**AERONAUTICAL CHARTING FORUM**  
**Instrument Procedures Group**  
**Meeting 14-02 – October 28, 2014**

**RECOMMENDATION DOCUMENT**

**FAA Control # 14-02-318**

**Subject:** Charting LNAV Engagement Altitudes

DANLS TWO DEPARTURE(RNAV)

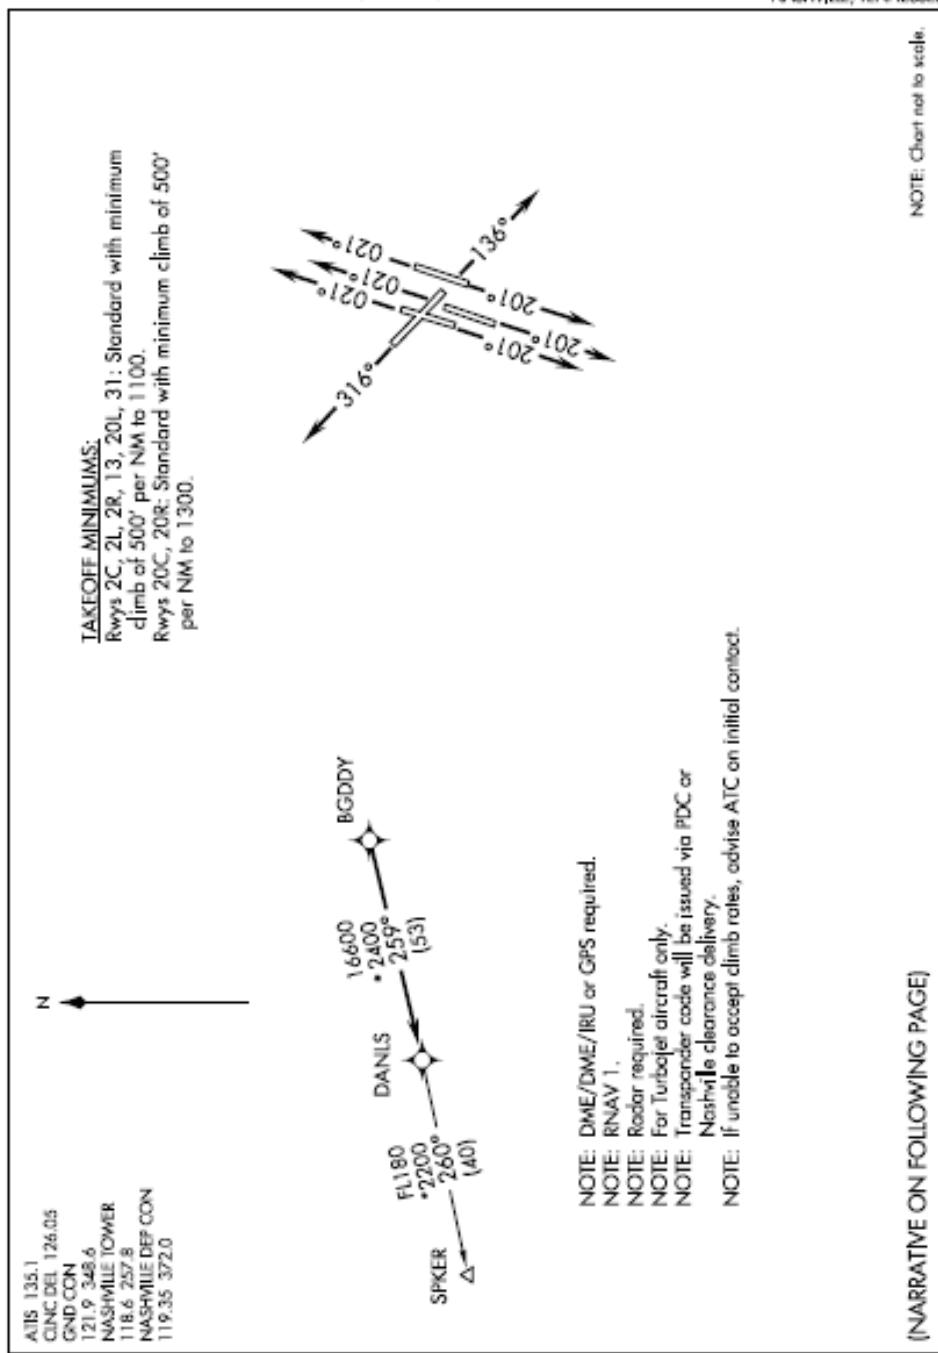
These inconsistencies have been showing up as ASRS/ASAP reports, complaints, and pilot deviations. Of the most recent errors, crews were leveling at the LNAV engagement altitude on new KOKC SIDs that are 500 ft. above the ground (a contributing factor could be that “Climb Via SID” clearance was issued instead of “Climb and Maintain”- the SID has no published constraints other than the LNAV engagement altitude.). Additionally, it has been shown that pilot knowledge of “LNAV engagement altitudes” is very low. In many cases, the designation is just ignored, producing an industry wide illusion of understanding. In fact, there appears to be very little published on the topic and the name alone is a misconception since a true “LNAV engagement altitude” varies by aircraft type and is designated by the manufacturer and certified by flight standards processes. There are also discussions occurring as to whether or not these LNAV engagement altitudes are “altitude constraints” at all and how they should be treated by ATC.

KBNA(DANLS2), KLAX (HOLTZ9), KLGA (JUTES2), and KOKC(MUDDE1)
